**RE: URBAN DESIGN COMMISSION SUBMITTAL – REQUESTING INITIAL APPROVAL
EDGEWATER HOTEL REDEVELOPMENT, 666 WISCONSIN AVENUE, MADISON, WISCONSIN**

DATE: February 4, 2010
TO: Amy Supple and Matt Morris, Landmark X, LLC
FROM: Betsy Powers and Mark Huber
SUBJECT: Stormwater Management for Proposed Edgewater Hotel Redevelopment

DATE: February 8, 2010
TO: Plan Commission
FROM: Robert F. Phillips, P.E., Interim City Engineer
SUBJECT: 666 Wisconsin Avenue Rezoning

C1.03

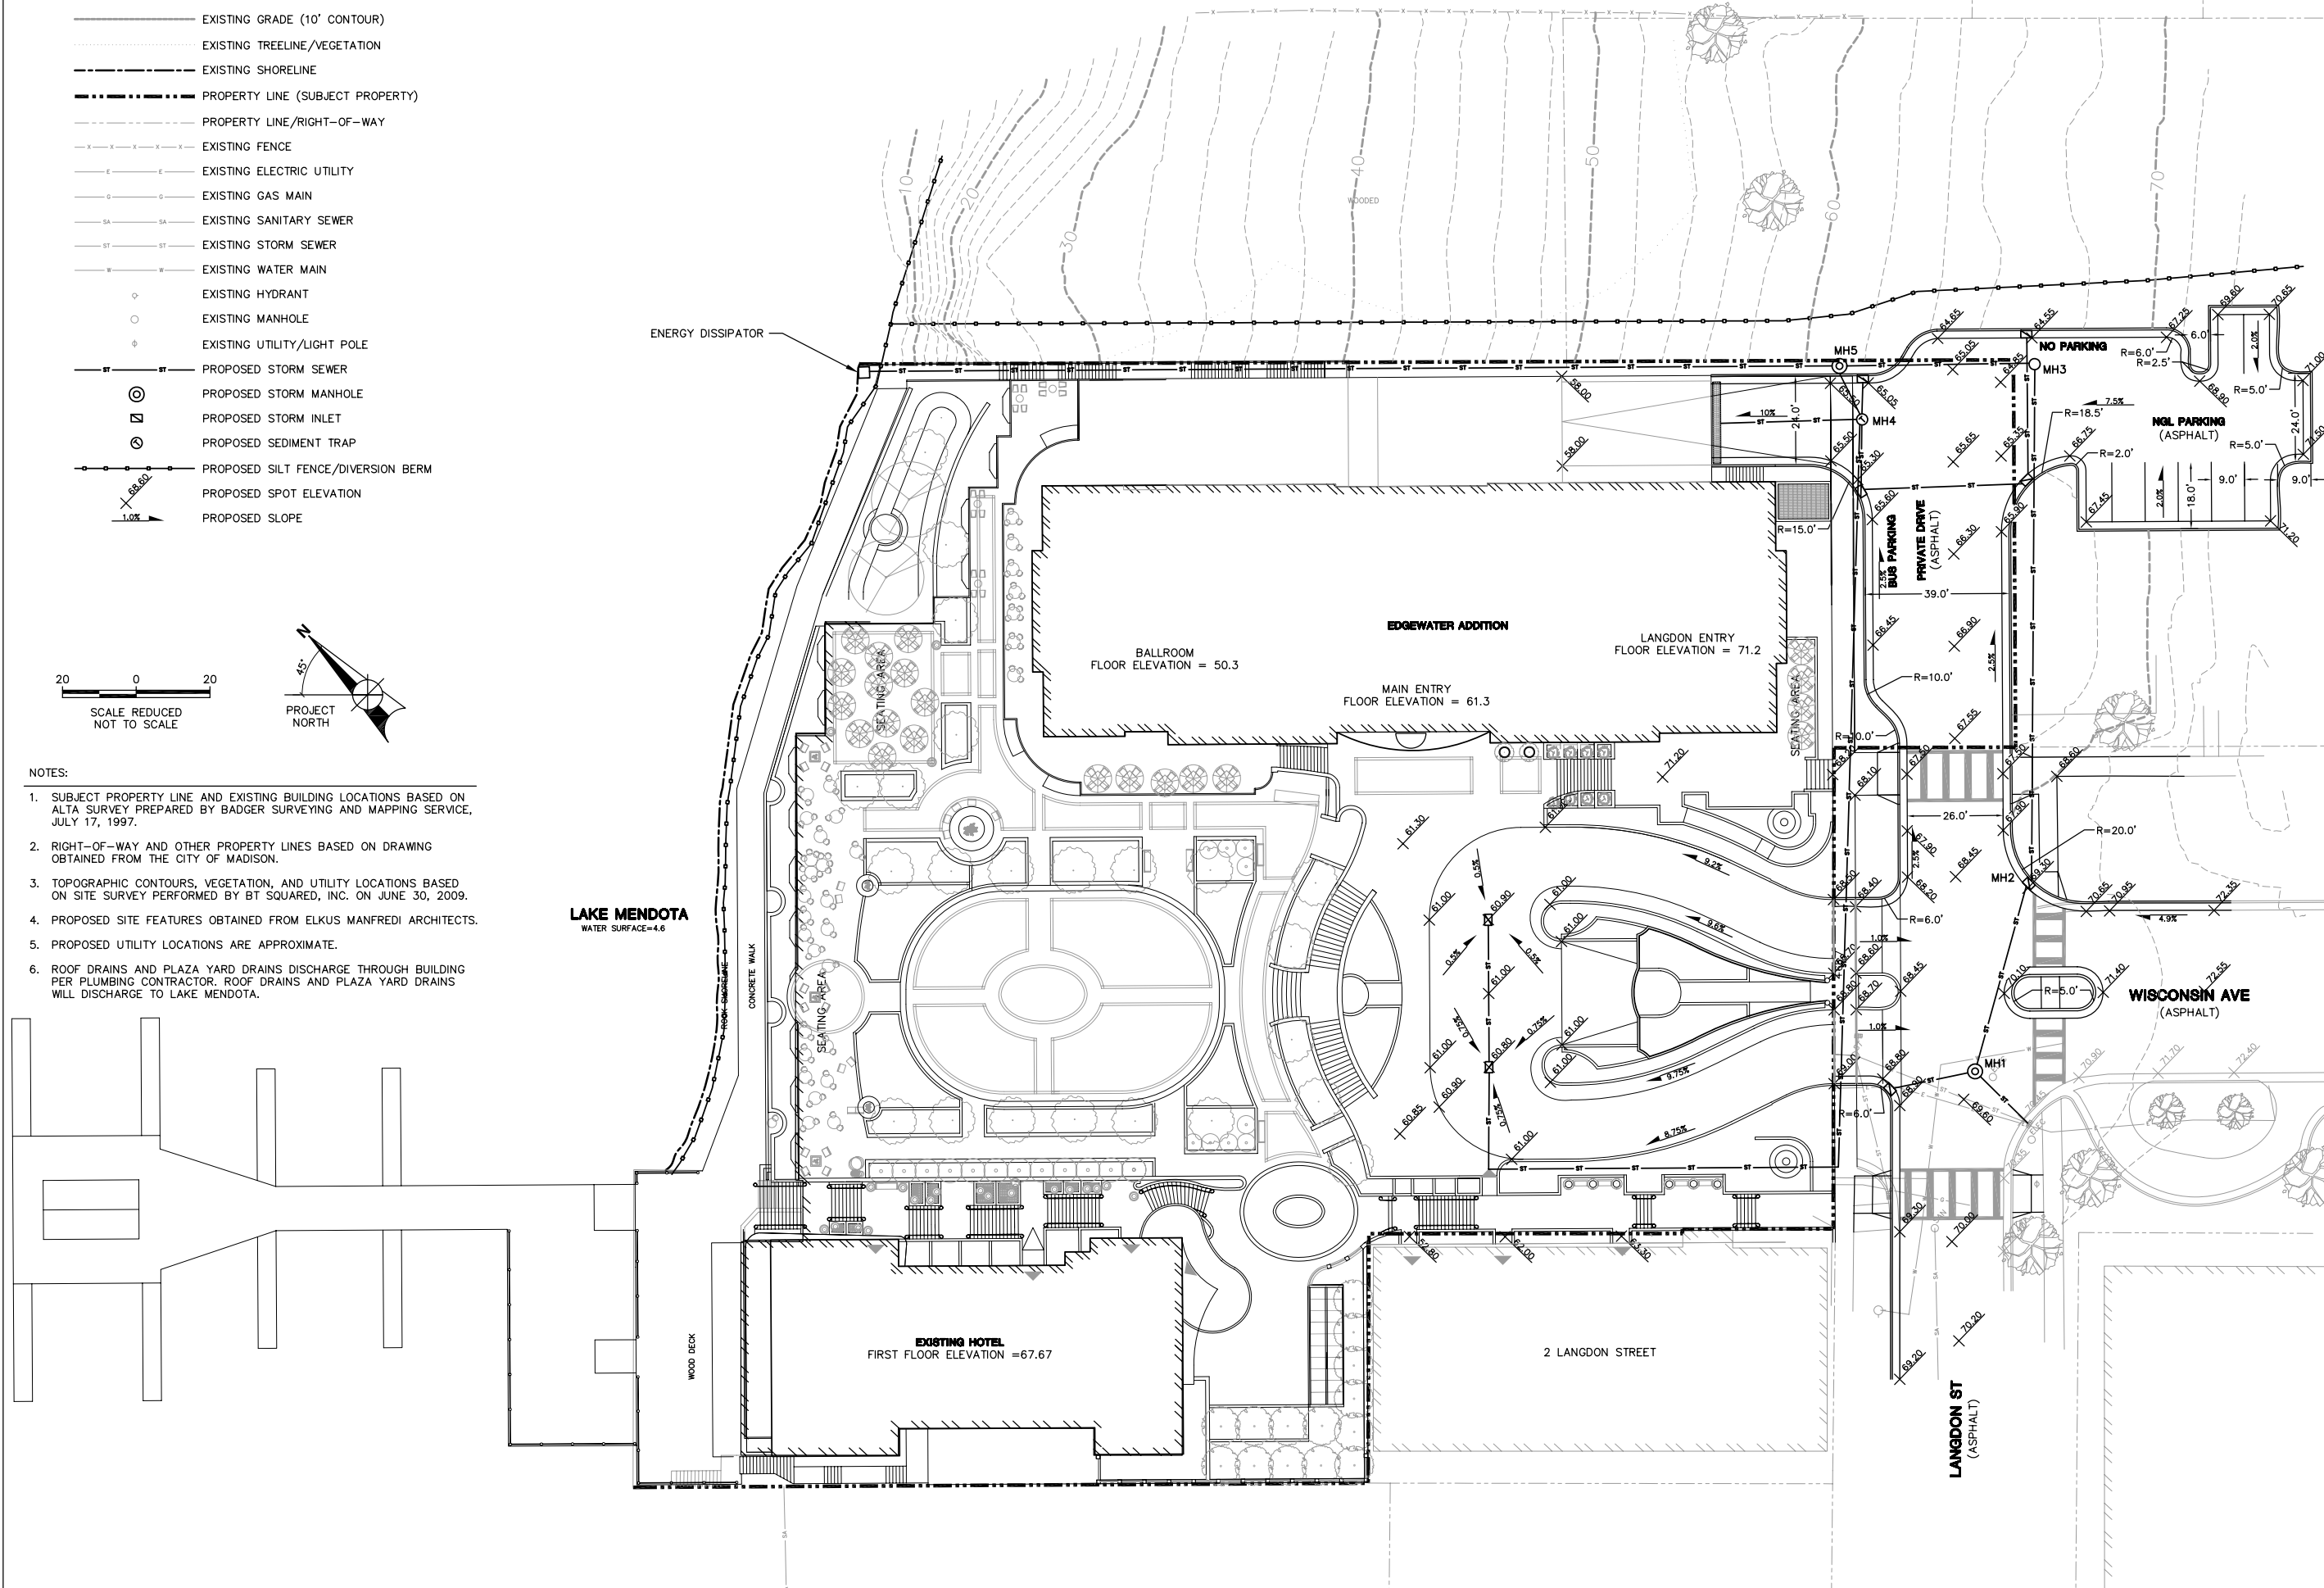
The following comments are related to the ongoing stormwater management plans as provided by the Edgewater Development team that the City is reviewing. The current plan requirements shall include the following, subject to change with any changes in the development plan:

1. Sediment control – required would be 40% TSS control off of paved surfaces. They are providing 72% TSS reduction using a filter device.
2. Oil and grease control – this filter device has hydrocarbon control built in.
3. Erosion control – a plan will be submitted ahead of construction both to the City and WDNR as part of a WRAPP (formerly NOI) permit.
4. Flood control – two (2) enclosed depressions on the site have safe overflow designed in for events exceeding pipe capacity.
5. Detention – not required (or recommended)
6. Infiltration – not required
7. Two additional 6x6 Catchbasins will be provided to treat the public street area that is not part of the private site but flows through the private site. This area is diverted around there primary treatment area due to capacity issues with the filters. They are not required to treat this area but are providing our standard treatment.
